SoCalGas-70

Blade Energy Partners' Response to SED Data Request-58

Response to SED Data Request-58

Blade response to the CPUC Data Request SED 58 related to Vertilog technology and the casing failure in SS-25 from Reply Testimony of Mr. Robert Carnahan on behalf of SoCalGas.

Figure 86: Macro Image of the Two Upper Turning Points and Single Arrest Point

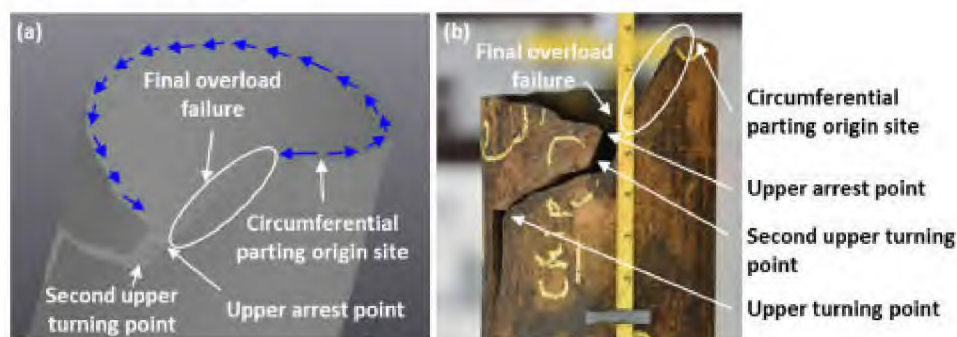
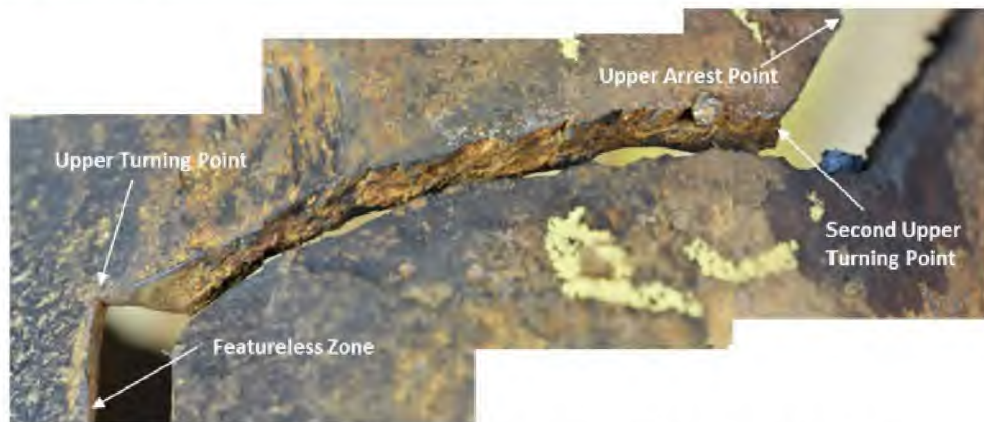
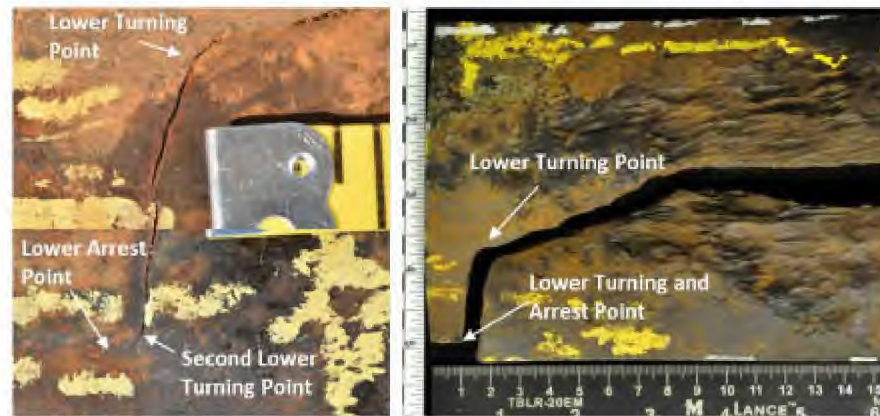
There are two issues raised here by Mr. Carnahan: (a) there is no fractographic evidence showing arrest of the vertical fracture extending upward from the area of the burst and (b) the vertical fracture extending downward from the area of the burst arrested most likely because it was approaching thicker material at the casing threaded connection. Blade's response to Mr. Carnahan's testimony is as follows:

Blade's Response to Issue (a): Blade did provide extensive macro and micro fractographic evidence showing arrest of the vertical fracture extending upward from the area of the burst. The evidence was provided and discussed in the *SS-25 Casing Failure Analysis* supplementary report on page 76 (Figure 78), page 81 (Figure 86, Macro), page 82 (Figure 87, Macro), page 109 (Figures 123, 124, Macro), page 121 (Figures 142 and 143, Macro), page 122 (Figure 144 Micro), page 124 (Figure 146 Micro), and page 146 (Figure 178 Macro).

As stated in the supplementary report, Figure 78 (page 76) and Figure 86 (page 81) illustrates the upper (upward) turning point, second upper (upward) turning point, and arrest point. The images show the upper (upward) section of the axial rupture. Figure 87 (page 82) shows the lower (downward) turning and arrest points.

Figure 81: (a) Front and (b) Top Views of Fracture Surface B Identifying Zones 1 and 2

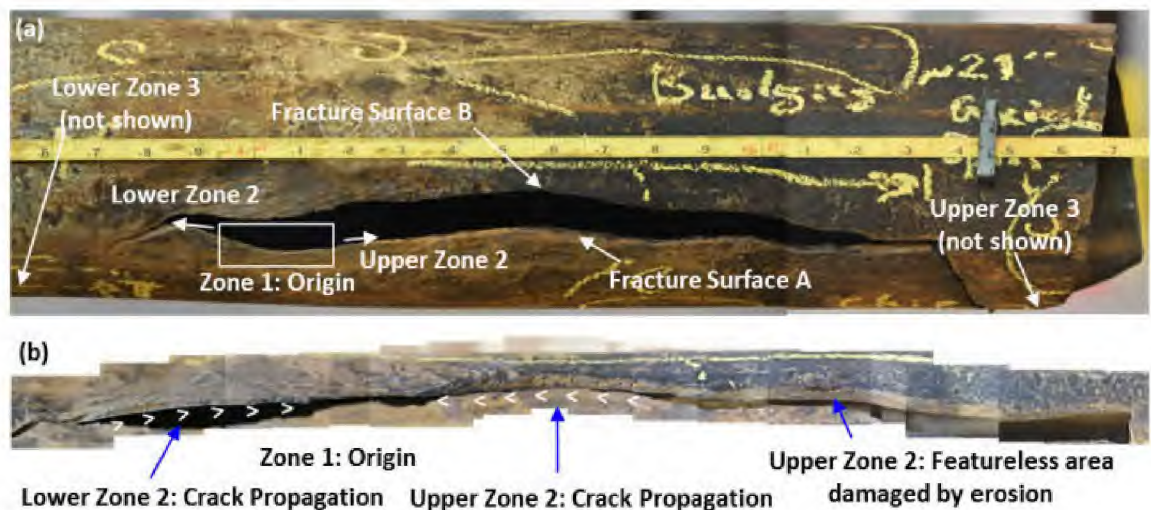
Issue (b): the vertical fracture extending downward from the area of the burst arrested most likely because it was approaching thicker material at the casing threaded connection.

Blade's response to Issue (b): Blade disagrees with Mr. Carnahan's statement that the crack may have arrested at the wall thickness change near the connection. The arrest point was about 9 in. from the start of the change in wall thickness of the casing pin connection, therefore the arrest is not coincident with the wall thickness change. However, Blade does agree that the connection contributed to the lower arrest point. Blade has addressed this issue in its supplementary report *SS-25 Casing Failure Analysis* (Section 3.2.1, page 78). Figure 81 (page 79) shows that the origin was not symmetrically located at the center of the rupture. The non-symmetric location of the origin can be explained by the proximity of the origin to connection 22. The axial crack initiated in Zone 1 and propagated in opposite directions. The lower (i.e., "downward" used by Mr. Carnahan) crack front propagated towards connection 22, which provided additional constraint. Parameters that may contribute to the constraint include connection make up stresses and residual stresses due to local deformation. The upper crack was not influenced by any additional constraint allowing the crack to propagate further before arresting.

Figure 19. Gas well temperature log showing cooling at the packer and perforation (Bird, 1954).

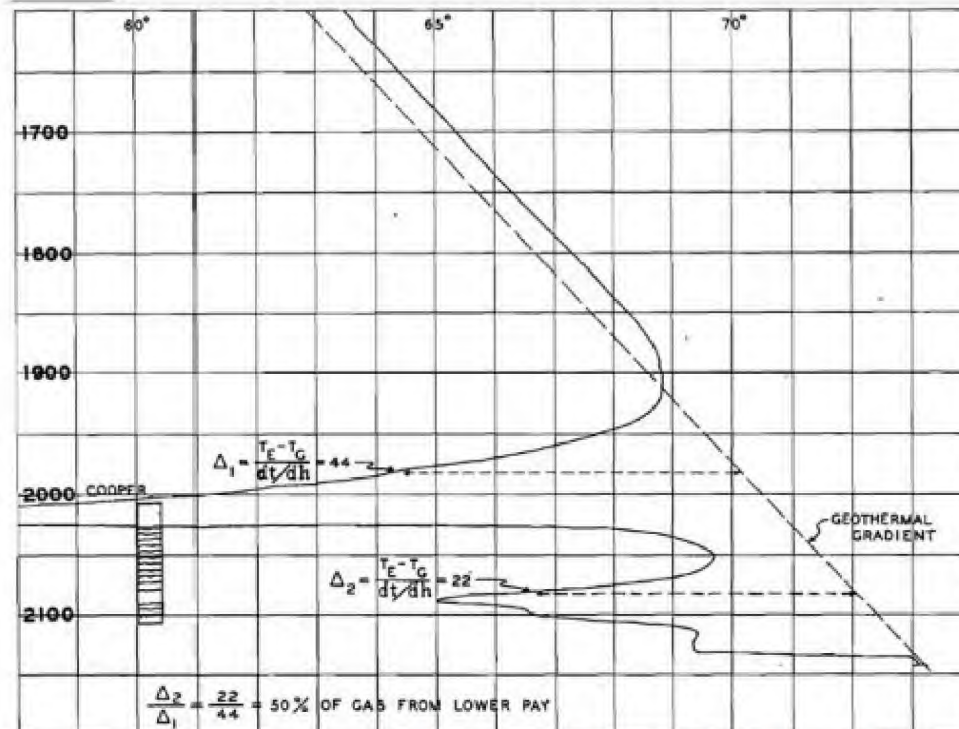
The cooling shown on the SS-25 temperature logs at this depth was not indicative of a leak. The movement of gas into or out of the storage zone always causes localized cooling; indeed, cooling behavior where a storage well meets the reservoir has been well known for many years, as can be seen in Figure 19.

Blade discussed this phenomenon in supplementary report *SS-25 Temperature, Pressure, and Noise Log Analysis* [26, p. 16].

Figure 22. Excerpt of SS-25 noise log performed on November 11, 1991.

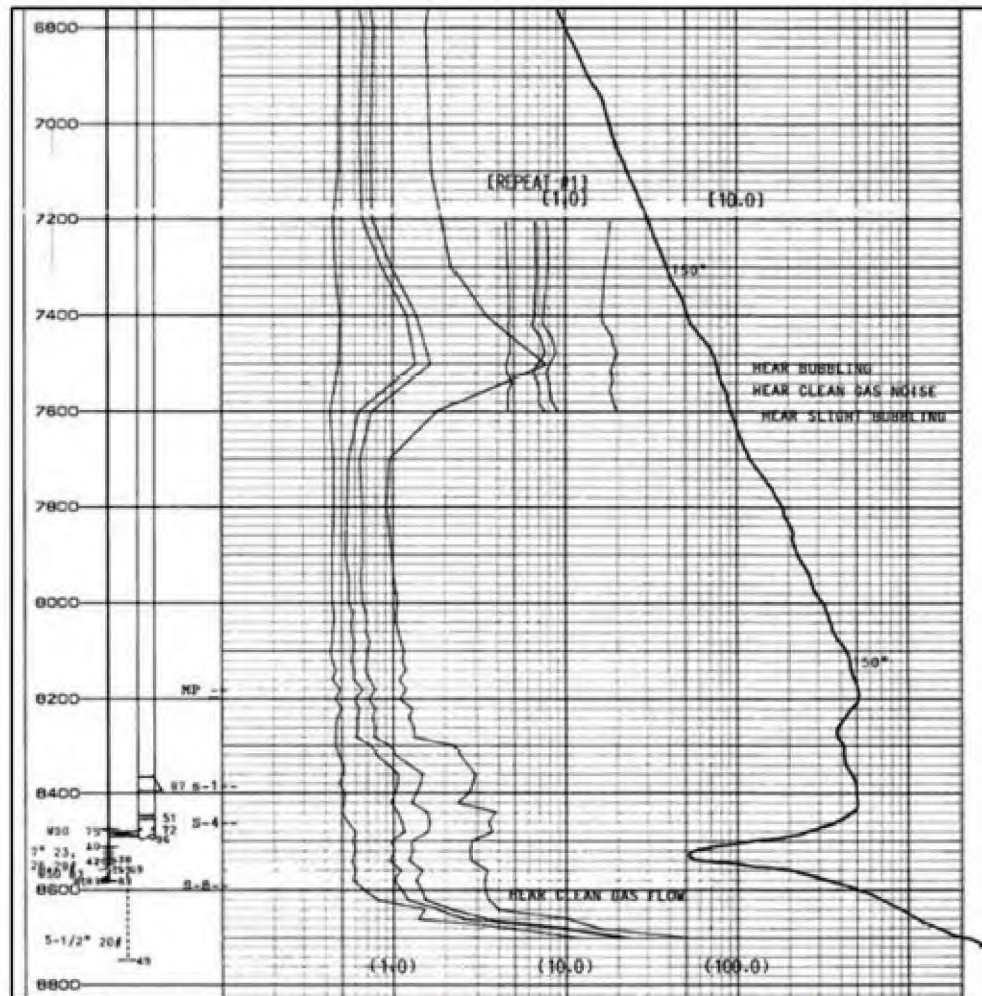
The same six logs also measured noise across all four frequency ranges slightly above the packer and completion equipment at the base of the well, and across the storage formation. Such noise is expected and is associated with movement of gas in the storage formation and through the completion equipment. The 1991 log includes operator comments regarding noise interpreted as "bubbling" at a depth of about 7,500 ft., which is shown in the excerpt of the log in Figure 22. As can be seen in the figure, the noise log was repeated over the depth range of 7,200 ft. to 7,600 ft. and the indicated bubbling noise was not detected.
